Gatwick Airport Northern Runway Project

Statement of Common Ground Between Gatwick Airport Limited and Environment Agency – Clean Version

VERSION: 3.0

Application Document Ref: 10.1.12

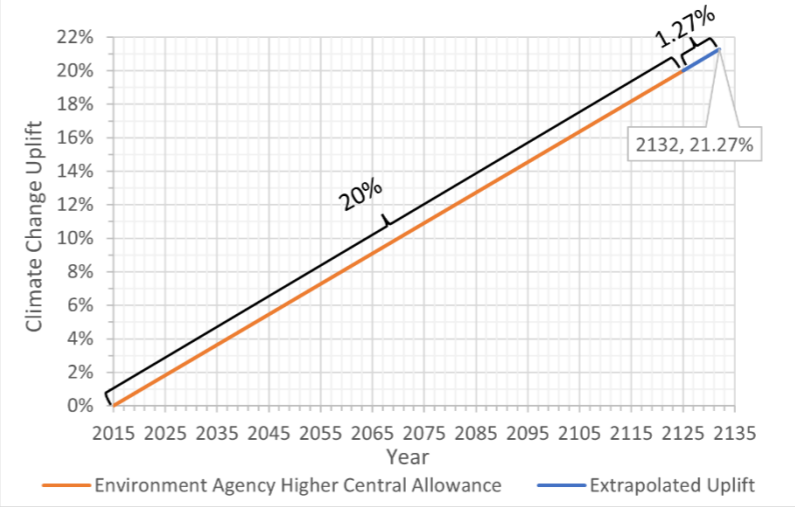
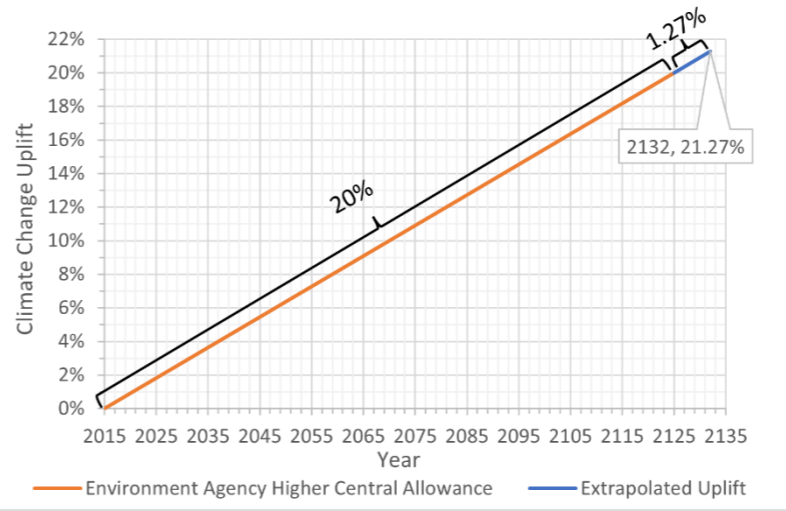
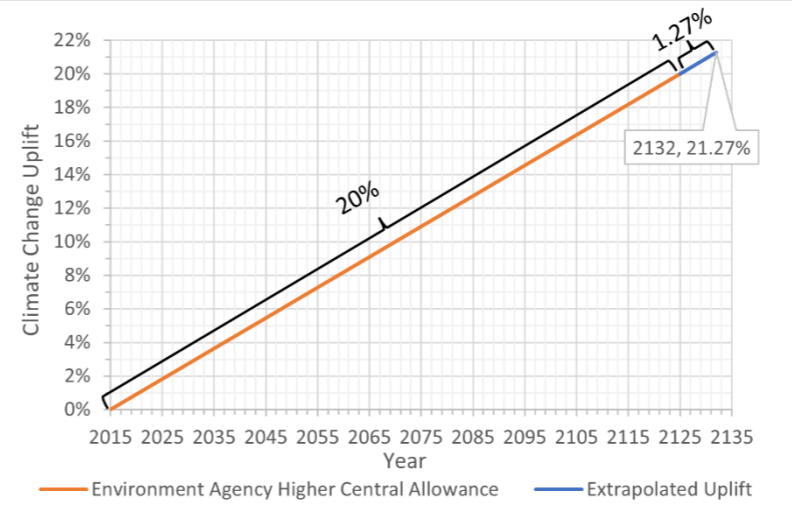
2.22.2.1	ES Appendix 11.9.6 Flood Risk Assessment	<p>The document states climate change and the associated increase in peak river flows for the River Mole Management catchment. Table 3.7.1 is reflective of the most up to date peak river flow climate change allowances from 2022. The applicant should consider the impact of climate change, clearly stating the development lifetime over which the assessment has been made.</p> <p>Updated position (Deadline 5) We note the submission of an updated fluvial modelling report to support the operation and functionality of the proposed Flood Compensation Areas. We would wish to review the FCA Delivery Plan. update to the fluvial modelling report and response to the queries below prior to agreeing this point, so we would consider 2.22.2.1 as still Under Discussion.</p> <p>The adopted lifetime for the airfield works is given as 40 years. During previous discussion, the applicant highlighted that although these have been assigned a 40-year lifetime, consideration of these elements as part of the wider 100 year lifetime for the overall development has also been undertaken. We request confirmation on this.</p> <p>In addition, it is noted the first full year of opening is considered to be 2032, giving the surface access work an adopted lifetime of 100 years up to 2132. We note the climate change figures for the 2080's epoch cover the period up to the year 2125. We require confirmation what consideration has been given to the time period between 2125 and the first full year of opening in relation to the design of the flood compensation/mitigation strategy.</p> <p>Relating to the adopted lifetime of the airfield works of 40 years, we have requested further information on why this lifetime was chosen and whether the airfield works are considered within the overall flood mitigation for the site which has a 100 year design life.</p> <p>Updated Position (Deadline 9)</p>	<p>The incorporation of the predicted impact of climate change is addressed in Section 3.7 of the FRA. The adopted lifetime for the airfield works of 40 years (up to 2069), and the adopted lifetime of the surface access works is 100 years (up to 2132).</p> <p>The fluvial and surface water flood risk assessment of the Project and its mitigation strategies were completed using the +20%/25% climate change uplift for the Central allowance, as well as +40% uplift for the Upper End allowance in accordance with Environment Agency guidance.</p> <p>Section 7 of the FRA demonstrates that through the provision of additional attenuation storage, floodplain connections (syphons) and floodplain compensatory storage the Project will not increase flood risk to other parties for its lifetime taking climate change into account.</p> <p>A Technical Note will be provided to the EA for discussion.</p> <p>Updated Position (Deadline 5): The Floodplain Compensation Area Delivery Plan (FCDP) and an update to the fluvial modelling report (ES Appendix 11.9.6 – Annex 5) will describe the philosophy and functionality of the proposed River Mole diversion and the two FCAs and the relationship of proposed works with these. The FCDP will be submitted to examination at Deadline 5, and the fluvial modelling report was shared with the EA in advance of Deadline 5 on 17 May 2024.</p> <p>Project design life: GAL met with the EA on 23 May 2024 to discuss the rationale for the airfield component of the Northern Runway Project being given a design life of 40 years. At this it was explained that the combination of the fluvial flood storage provided by the River Mole and the proposed FCAs at Museum Field and Car Park X will provide off-site flood protection in excess of 100 years plus 40% climate change (the credible maximum scenario)</p>	<p>ES Appendix 11.9.6: Flood Risk Assessment [REP6-053]</p> <p>The Applicant's Response to Deadline 7 Submissions (Doc Ref. 10.65)</p>	Agreed

Reference	Matter	Stakeholder Position	Gatwick Airport Limited Position	Signposting	Status
		<p>The applicant has added additional information to Appendix 11.9.6: Flood Risk Assessment (FRA) with the latest being Version 3.0 dated June 2024. This document contains an expanded Executive Summary which includes further information on the choice of lifetimes for the proposed development, and importantly, confirmation that the project as a whole considers the 100-year lifetime for the purposes of the management of flood risk.</p> <p>Further information has been provided by the applicant regarding climate change for peak river flow and the 100-year lifetime of the development. Previously, the applicant has suggested using the 40% uplift as a proxy to consider the 7 years beyond 2125, up to 2132. The applicant has now also linearly extrapolated the higher central allowance of 20% for the additional 7 years to 2132, with the result a suggested 1.27% uplift. Although it would be useful to see some additional detail on this extrapolation, such as more description on methodology or the information in a graphical format within the Flood Risk Assessment (FRA), this additional work suggests the use of the 40% uplift as a proxy is reasonable to consider the additional 7 years lifetime of the development</p> <p>Updated Position August 2024 The addition of further explanation on the extrapolation methodology and the addition of a graph to visually depict how the uplift has been calculated is welcomed.</p>	<p>for the Project as a whole – i.e. to beyond 2025. The FRA will be updated to make this clearer and shared with the EA for comment in advance of formal submission to the examination at Deadline 6.</p> <p>Updated Position July 2024 The Applicant submitted an updated FRA at Deadline 6 [REP6-053] which clarifies Gatwick’s position in relation to the issues raised. Further clarification regarding the consideration of climate change between 2125 and 2132 is also provided within The Applicant’s Response to Deadline 7 Submissions shared at Deadline 8.</p> <p>Updated Position August 2024 The Environment Agency’s climate change allowances use 2015 as the baseline. Therefore, to extrapolate the climate change uplift for the additional 7 years beyond 2125 to 2132, the 20 per cent Higher Central climate change allowance for the 2080s epoch was first divided by 110, the number of years between 2015 and 2125. This annual uplift was then multiplied by 7 to estimate the total potential uplift over a 7-year period, 1.27 per cent. The potential uplift between 2015 and 2132 is illustrated in the graphic below.</p>
